STANDEL SERVICE INFORMATION

ACOUSTIC MAGNIFIERS AND PA COLUMN AMPLIFIERS
PB50, PB100, AM48, AM48S, AM30, AM30S
AM24, AM24S

CROSS-OVER CORRECTION FOR ALL 1968 ACOUSTIC MAGNIFIERS

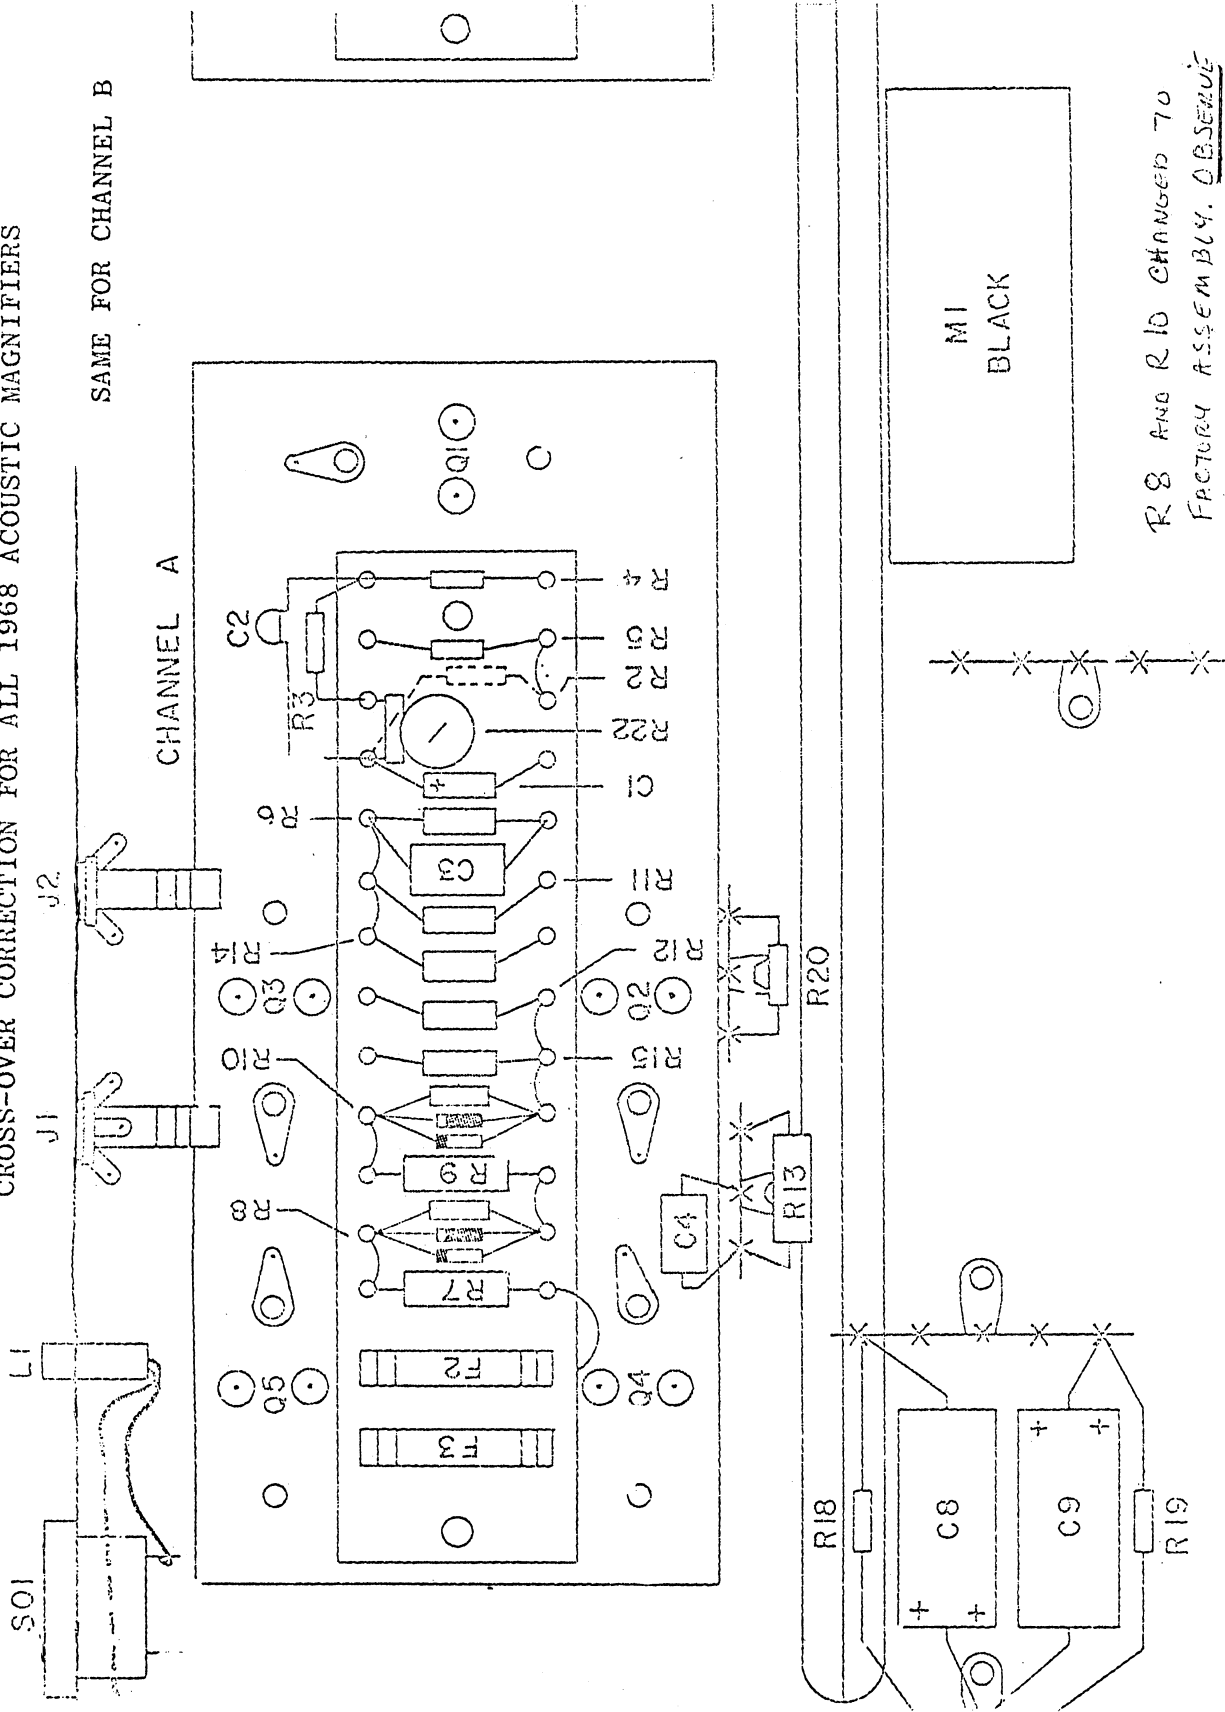
In some cases under low power line voltage conditions, the amplifier will develop low level distortion which sounds very much like a bad speaker.

The problem will generally occur at line voltages below 115V when the amplifier is played at low volume levels.

R8 AND R10 CHANGED TO
FACTORY ASSEMBLY. OBSERVE
POLARITY
R7 AND R9 CHANGED TO
2.7K 1W 5%

This can be eliminated by replacing resistors R7, R8, R9, and R10 as shown on the schematic diagram. Replacement kit must be obtained from the Standel Company. When ordering replacement kit, please send the model and serial number of the amplifier involved.
